# International Aero Engines SERVICE BULLETIN

Subject: Transmittal of Revision 2 to Service Bulletin  
No.V2500-ENG-72-0234

**ENGINE - LP COMPRESSOR - TRIMMING OF ANNULUS FILLER PLATFORM EDGE**

**V2500-ENG-72-0234**

Check the gaps between the Annulus Fillers  
and the Stage 1 LP Compressor Fan Blade  
Figure 1

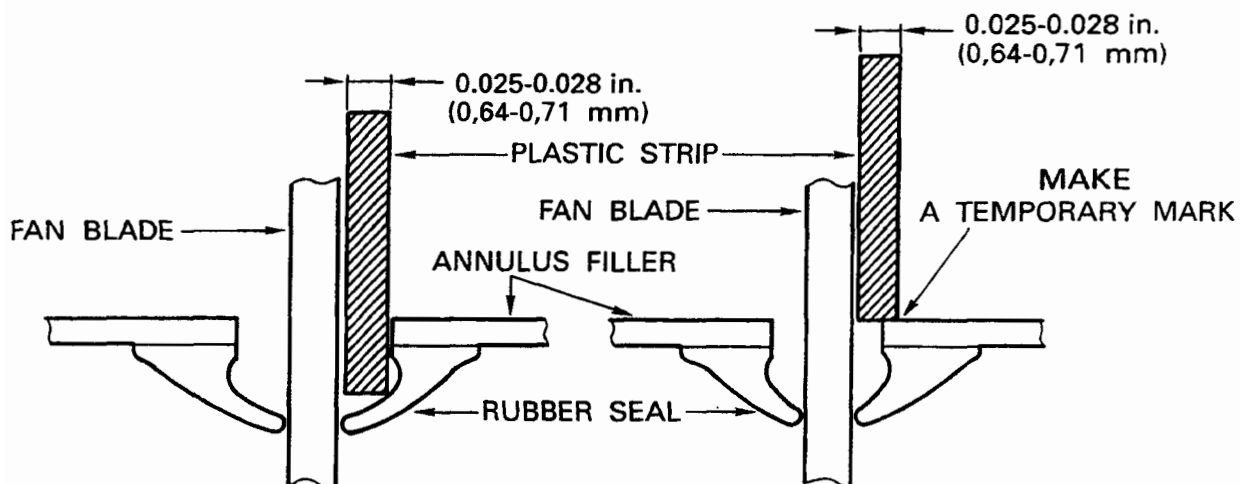
It was found for some engines that the gap between the Annulus Filler and the Fan Blade was too narrow in the leading edge portion of convex side of the Fan Blade.

- (1) This Service Bulletin applies to the engines which experienced the N1 Vibration Shifting.
- (2) This Service Bulletin introduces the trimming of the platform edge of the 5A1459, 5A1611 or 5A1710, Annulus Filler to keep each gap between the Annulus Filler and the Stage 1 LP Compressor Fan Blade by minimum 0.025 in (0,64 mm).
- (3) Existing Annulus Fillers, which have not kept the gap minimum 0.025 in (0,64 mm), should be reworked (See Figure 1).

(1) Check each gap between the 5A1459, 5A1611 or 5A1710 Annulus Filler and the Stage 1 LP Compressor Fan Blade as follows:  
(Refer to Figure 1)

- (2) Make a temporary mark on the Annulus Filler with the width 0.025 - 0.028 in (0,64 - 0,71 mm) from the Fan Blade using the Plastic Strip (Refer to Figure 1).

PUT THE PLASTIC STRIP INTO THE GAP BETWEEN THE ANNULUS FILLER AND THE CONVEX SIDE OF THE FAN BLADE, AND TRAVERSE IT. IF IT STUCK IN THE GAP, MARK ON THE ANNULUS FILLER.

Trimming of the Annulus Filler Platform Edges  
Figure 4

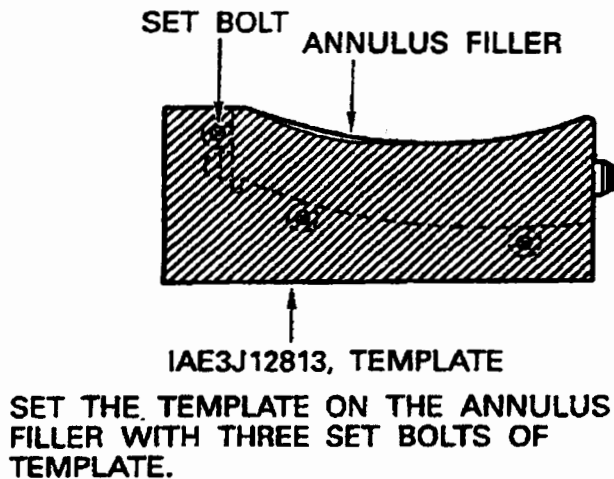
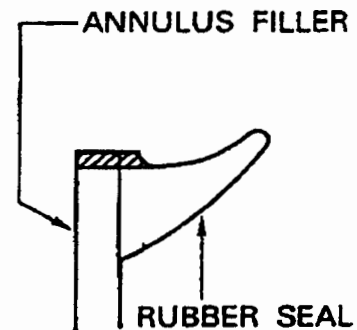
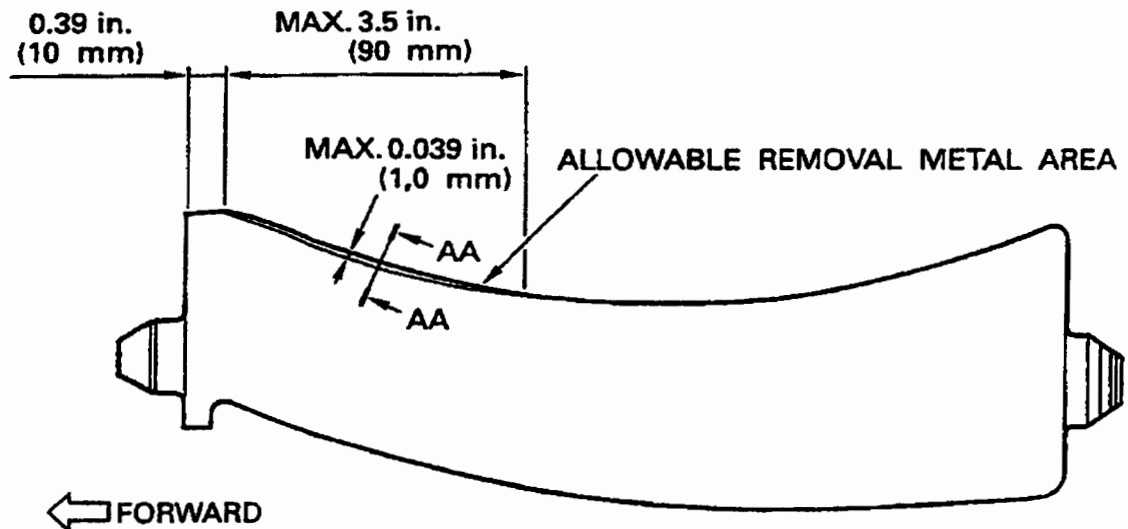
- c) Make the temporary mark numbers 1 through 22 on each Annulus Filler in counterclockwise from the Correlation Mark when you look from the rearward.  
Use the CoMat06-069 Felt Tip Marker.
- d) Remove the Front Retaining Ring by the approved procedures in Reference (2) (In Service) or Reference (3) (In Shop).
- (3) Remove the 5A1459, 5A1611 or 5A1710, Annulus Fillers which have been marked in Paragraph B (2) due to the narrow gaps by the approved procedures in Reference (2) (In Service) or Reference (3) (In Shop). (Refer to Figure 3)
- (4) Check the profile of each Annulus Filler removed with the IAE3J12813, Annulus Filler Trimming Template; make sure whether the mark made in Paragraph B (2) is hidden under the Template or not. (Refer to Figure 4)

If the mark is not hidden and out of the Template, do Paragraph D for trimming of the Annulus Fillers.

R But, If the mark is hidden under the Template, or if the  
R "SB 72-0234 MAX" is marked adjacent to the part number, replace  
R the Fan Blade instead of Paragraph D by the approved procedures  
R in Reference (2) (In Service) or Reference (3) (In Shop).

<u>Procedure</u>	<u>Supplemental Information</u>
R a) Trim the Annulus Filler along R with the temporary mark made R in Paragraph B. (2) R or by maximum amount R R R R R R	Refer to Figure 4 for minimum amount trimming, refer to Figure 4A for maximum amount trimming, Refer to Reference (4) , TASK 70-35-03-300-501 Hand Polish and Blend Procedure.

TRIM THE HATCHED AREA

Trimming of the Annulus Filler Platform Edges  
Figure 4A

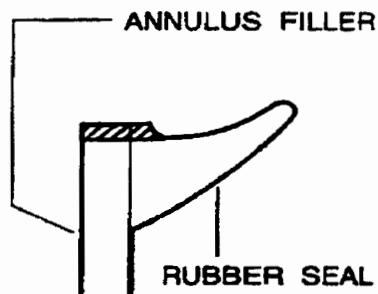
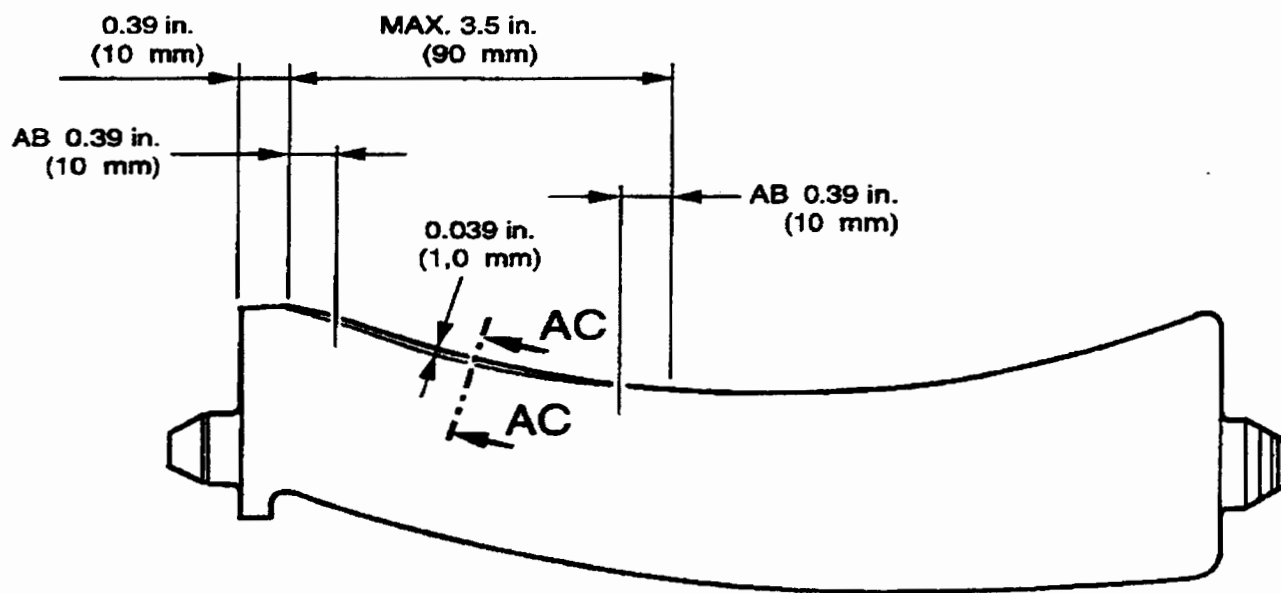
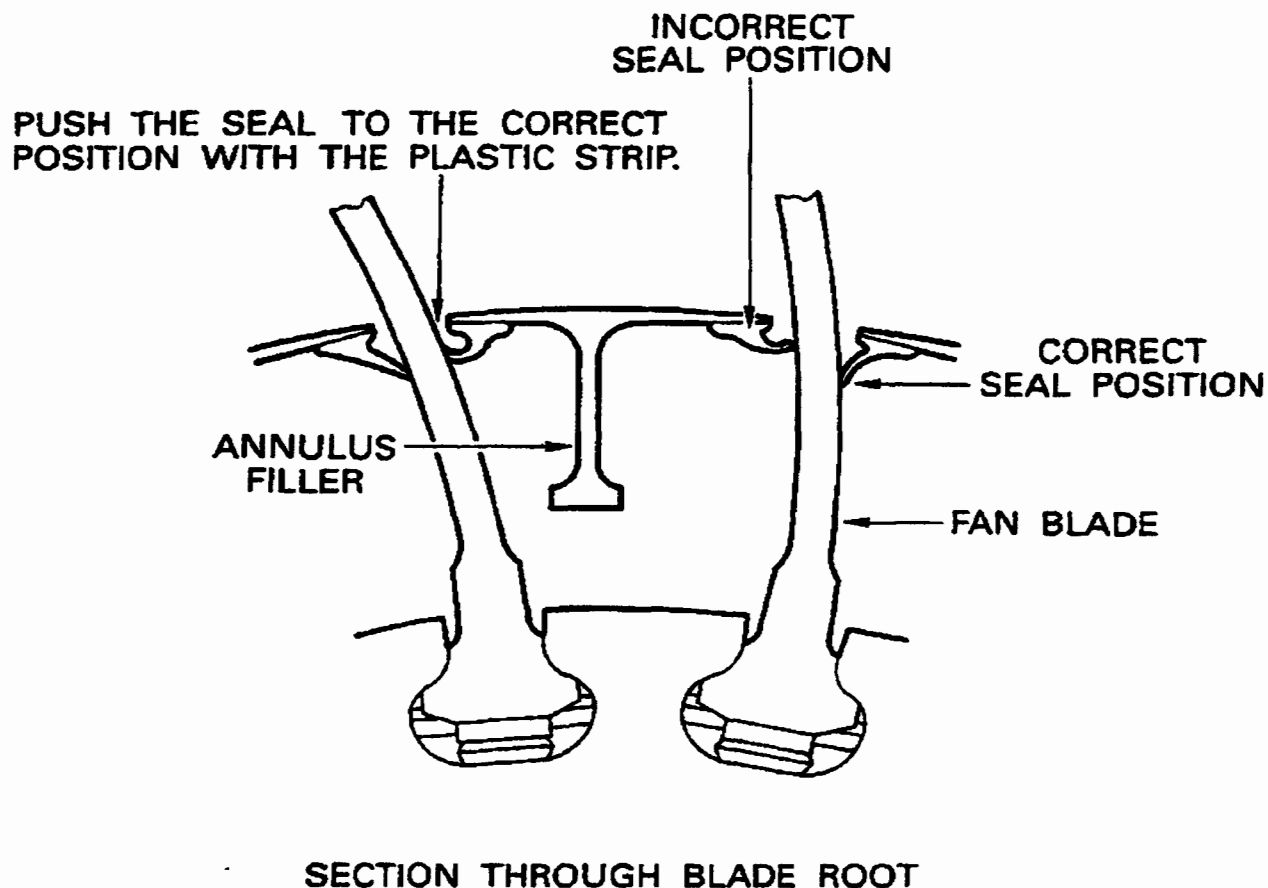
R If the IAE3J12813, Annulus Filler Trimming Template is not  
R available, you can do a rework of the Annulus Filler one time  
R by trimming the maximum amount.

R CAUTION: THE ANNULUS FILER TRIMMED MAXIMUM AMOUNT MAY INCREASE THE  
R POSSIBILITY OF RUBBER SEAL FLIPPING AT OPERATION WHICH MAY  
R RESULT IN THE LOW PRESSURE ROTOR VIBRATION PROBLEM.

**NOTE:** DECREASE THE TRIMMING DEPTH FROM 0.039 in. (1.0 mm) TO 0 in. (0 mm) UNIFORMLY IN AREAS AB.
